SERVING SOLUTIONS
DINING ROOM TOOLS

HIGH CHAIR MODIFICATION

ASTM F404-18 Compliant

Old design

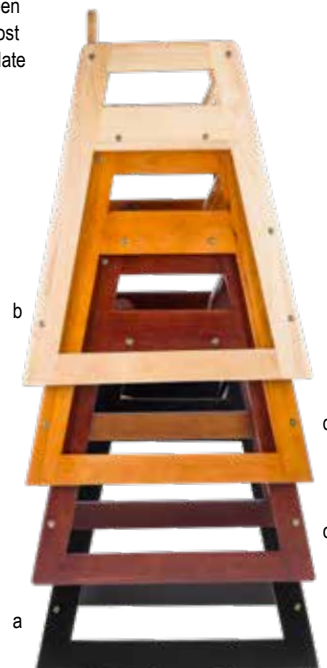
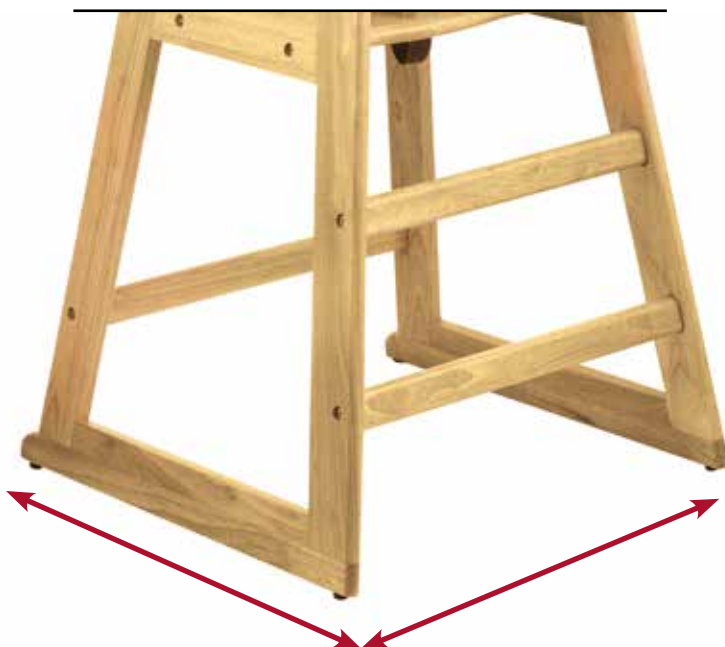
New ASTM F404-18 compliant warning labels can be found on the front of the back rest.

Permanent passive restraint added to the front of the chair and the height of the back rest have been increased to keep child more securely in their seat.

The gaps on side panels between arm rests and seat have been reduced to prevent children's limbs from getting lodged.

Split washers will be used with all bolts to prevent them from loosening.

Increased stance and extended base bars added for stability and reduced risk of tipping.
